Document ID: IK1900233
Revision: 0
Created: 10/15/2014
Last Modified: 10/20/2014
Author: Kevin Kochanek

Title: 16UZL No Idle HVAC Solution Parts Identification

Applies To: ProStar and LoneStar

Figure 1. 150A Relay Identification.

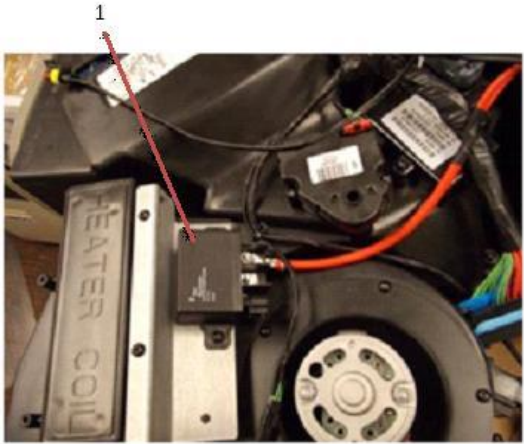
If a vehicle has the 150A relay (Figure 1, Item 1) on the HVAC unit, it either had the kit installed or was built after 23 June 2014. Please note that when replacing the full HVAC unit, the battery harness needs to be replaced if the vehicle did not have the 150A relay installed previously.

Figure 2. Unmodified HVAC Prior to 23 June 2014 Production.
 Item 1: Battery harness
 Item 2: HVAC power harness
 Item 3: GND wire
 Item 4: HVAC controller
 Item 5: Battery
 Item 6: 60A cube fuse

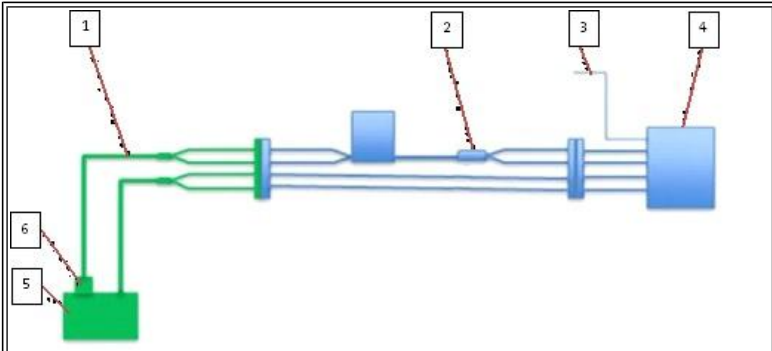
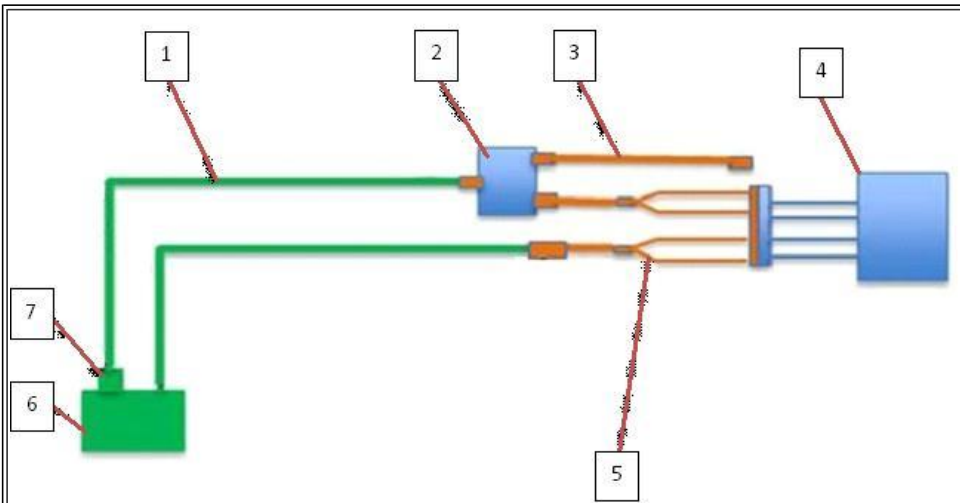
Beginning on 23 June 2014, production changed to an updated No-Idle HVAC unit, harness, and mating battery harness. The table below can help identify what parts to order to ensure you have compatible components. The HVAC and battery harnesses connect to a 150A relay (Figure 1).

NOTE:
 Beginning on 23 June 2014, production changed to an updated No-Idle HVAC unit, harness, and mating battery harness.

Figure 3. Updated Production as of 23 June 2014.
 Item 1: Battery harness
 Item 2: 150A relay
 Item 3: Relay control jumper harness
 Item 4: HVAC controller
 Item 5: HVAC power harness
 Item 6: Battery
 Item 7: 60A cube fuse
